# Access Compliance Report

## Public Rights-of-Way

| Intersection ID: 16798                  | Main Street: SELWYN FARMS LN | Cross Street: WATER WHEEL CT            | Location: S            |
| ADA ID: 678F5B4750F9                    | Ramp Type: PerpDiag          | Initial Pass/Fail: Fail                 | Overall Compliance: No |

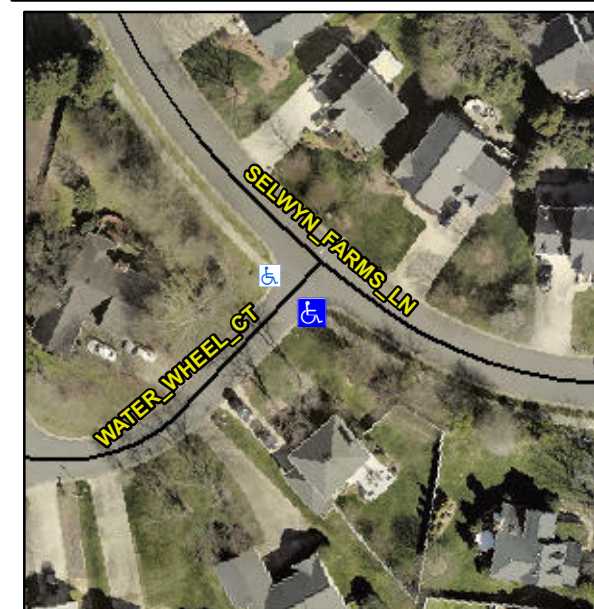
**R304.2.2**

| Compliance | Description           | Data  | Compliance | Description                 | Data  |
|------------|-----------------------|-------|------------|-----------------------------|-------|
| N/A        | Ramp Length (in)      | 34.0  | No         | Ramp Slope (%)              | 11.4  |

**Remove & Replace Curb Ramp With Two New Directional Ramps or Equivalent.**
